# Proposal for SAS 2.x Specification to Enable Support for Active Cables

Gourgen Oganessyan

QUELLAN

June 5, 2008

**Figure 98 — Mini SAS 4x cable plug connector that attaches to an enclosure universal port**

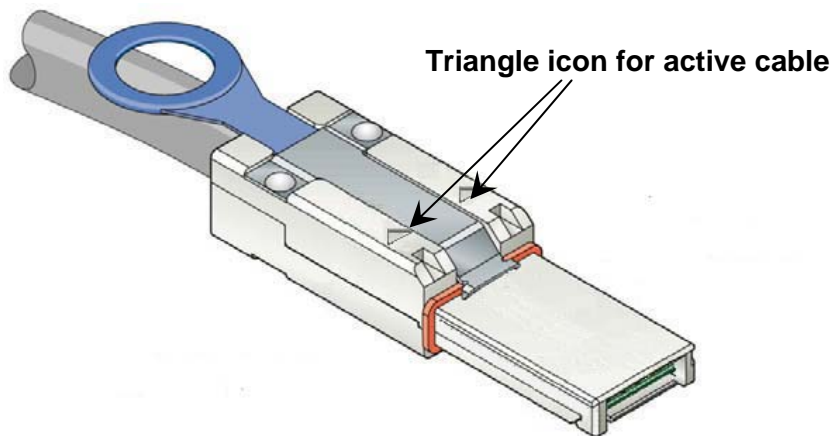
In order to ensure that active cables cannot be plugged into legacy (passive) ports, differentiating keying shall be provided by removing all the key slots from the plug connector and all the keys on the receptacle connector. In addition, two triangle icons on each side on the plug connector will be added to the plug connector to distinguish an active cable assembly (Figure 98).

Figure 98 shows an active mini SAS 4x cable plug connector that attaches to an enclosure universal port:
